NEW RESIDENCE

1385 HILLSIDE CIRCLE, (LOT 3) BURLINGAME, CA
A.P.N.: 000-000-000

NOTES		REVISED RECEIVED October 14, 2025 City of Burlingame CDD-Planning DIV CONSTRUCTION SCHEDULE 1. NO PERSON SHALL ERECT (INCLUDING EXCAVATION AND GRADING), DEMOLISH, ALTER OR REPAIR ANY BUILDING OR STRUCTURE OTHER THAN BETWEEN THE FOLLOWING HOURS EXCEPT IN THE CASE OF URGENT NECESSITY IN THE INTEREST OF PUBLIC HEALTH AND SAFETY, AND THEN ONLY WITH PRIOR WRITTEN APPROVAL FROM THE BUILDING OFFICIAL, WHICH APPROVAL SHALL BE GRANTED FOR A PERIOD NOT TO EXCEED THREE DAYS. HOLIDAYS ARE THE FIRST DAY OF JANUARY, THE THIRD MONDAY OF FEBRUARY, THE LAST MONDAY OF MAY, THE FOURTH DAY OF JULY, THE FIRST MONDAY OF SEPTEMBER, THE ELEVENTH DAY OF NOVEMBER, THE FOURTH THURSDAY IN NOVEMBER AND THE TWENTY FIFTH DAY OF DECEMBER. IF THE FIRST DAY OF JANUARY, THE FOURTH DAY OF JULY, THE ELEVENTH DAY OF NOVEMBER AND THE TWENTY-FIFTH DAY OF DECEMBER FALLS UPON A SUNDAY THE FOLLOWING MONDAY IS A HOLIDAY. PROVIDE THE FOLLOWING CONSTRUCTION HOURS ON THE PLANS PER CITY OF BURLINGAME MUNICIPAL CODE 18.07.110. i. MONDAY THROUGH FRIDAY: 8AM TO 7PM ii. SATURDAYS: 9AM TO 6PM iii. SUNDAY AND HOLIDAYS: NO WORK 2. CONSTRUCTION HOURS

SITE DEMOLITION PLAN
SCALE: 3/32"=1'-0"

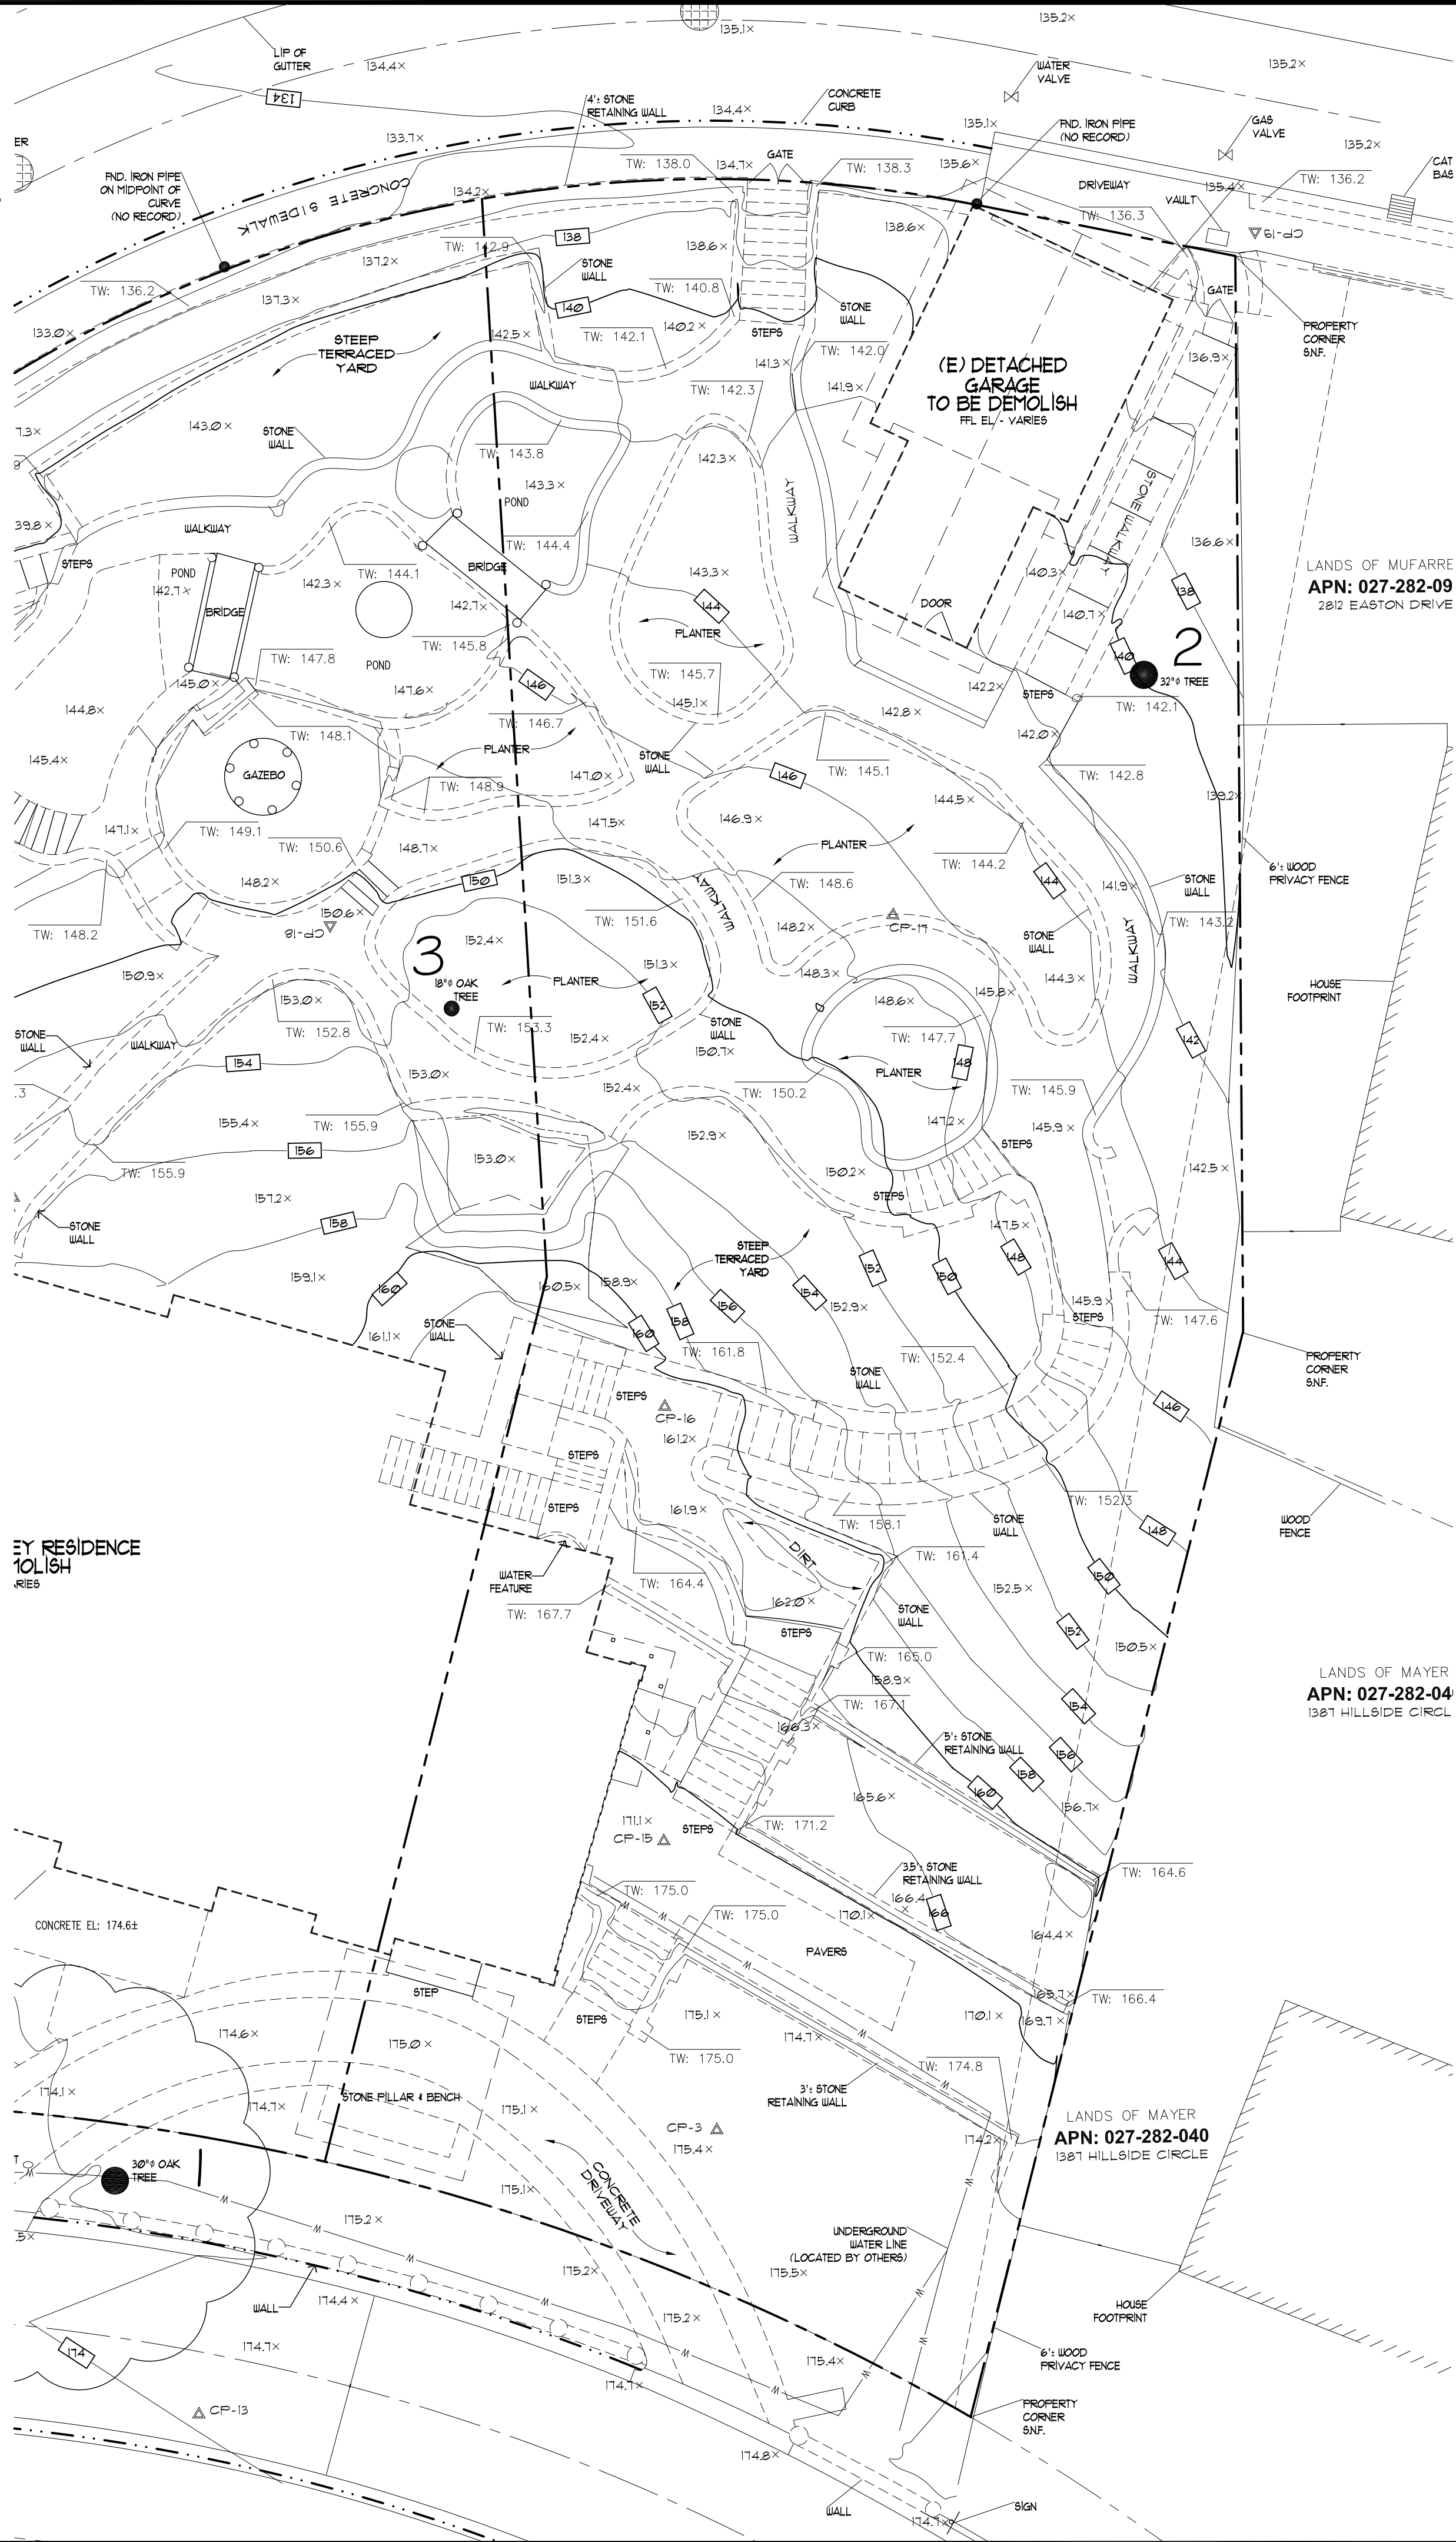
ENSURE THAT TREE PROTECTION SPECIFICATIONS ARE SHOWN GRAPHICALLY ON SITE PLANS FOR CONTRACTOR TO FOLLOW, AS FOLLOWS:

LOCATION OF ALL TREE PROTECTION MEASURES INCLUDING BUT NOT LIMITED TO FENCING, TRUNK WRAP, ROOT BUFFER, ARE TO BE GRAPHICALLY SHOWN ON DEMO PLAN A2 SO THAT CONTRACTOR CAN EASILY INSTALL AND EXECUTE THE TREE PROTECTION MEASURES.

LOCATIONS OF HAND DIGGING AND LOCATIONS OF WORK TO BE UNDER PROJECT ARBORIST SUPERVISION ARE TO BE GRAPHICALLY SHOWN ON THE RELEVANT SITE PLAN SO THAT CONTRACTOR(S) CAN EASILY UNDERSTAND AND EXECUTE THE SPECIFICATIONS. WORK WITH THE PROJECT ARBORIST TO PRODUCE ACCURATE INFORMATION ON THE RELEVANT SITE PLAN. SOME OF THE INFORMATION WILL BE ON THE A SHEETS AND SOME ON THE L SHEETS.

ARBORIST REPORT RECOMMENDS:
RETAINING SOME OF THE DRIVEWAY NEAR TREE 1 AND BREAKING IT DOWN BY HAND LATER IN THE PROJECT. PUT THIS ON DEMO PLAN A2 SO CONTRACTOR CAN FOLLOW IT.
CHANGING THE PATHWAY NEAR TREE 10 TO AVOID ROOT LOSS/DAMAGE. WHERE IS TREE 10? HAS THE PATHWAY BEEN CHANGED?

ARBORIST REPORT IS BASED ON REVIEWING L PLANS DATED JAN 2024, LOT 1 A PLANS DATED 10-26-22, LOT 2 A PLANS DATED 10-26-21 AND LOT 3 A PLANS DATED 10-26-21. NO CIVIL PLANS REVIEWED. NOTE THAT THE CONTENT OF CIVIL PLANS MAY NECESSITATE A CHANGE IN THE ARBORIST RECOMMENDATIONS.

INDICATE THAT AT LEAST 3 SINGLE-TRUNKED LANDSCAPE TREES WILL BE PRESENT ON EACH LOT, AS NOTED BELOW.
PER CHAPTER 11.06, THIS PROJECT REQUIRES 3 SINGLE-TRUNKED LANDSCAPE TREES FOR LOT 3.
TREES MAY BE EXISTING OR NEW.
REQUIRED TREES MAY NOT BE FRUIT OR NUT TREES, PALMS, ITALIAN CYPRESS OR JAPANESE MAPLE.
REQUIRED TREES MUST HAVE A MATURE HEIGHT OF OVER 15 FEET.
ALL REQUIRED TREES MUST BE IN GOOD CONDITION AT THE FINAL ARBORIST INSPECTION.
STREET TREES DO NOT COUNT TOWARDS THE REQUIRED TOTAL.

PROVIDE THE BOTANICAL NAME (GENUS AND SPECIES) AND LOCATION OF THE REQUIRED LANDSCAPE TREES, AND WHETHER THEY ARE EXISTING OR NEW, FOR EACH LOT.
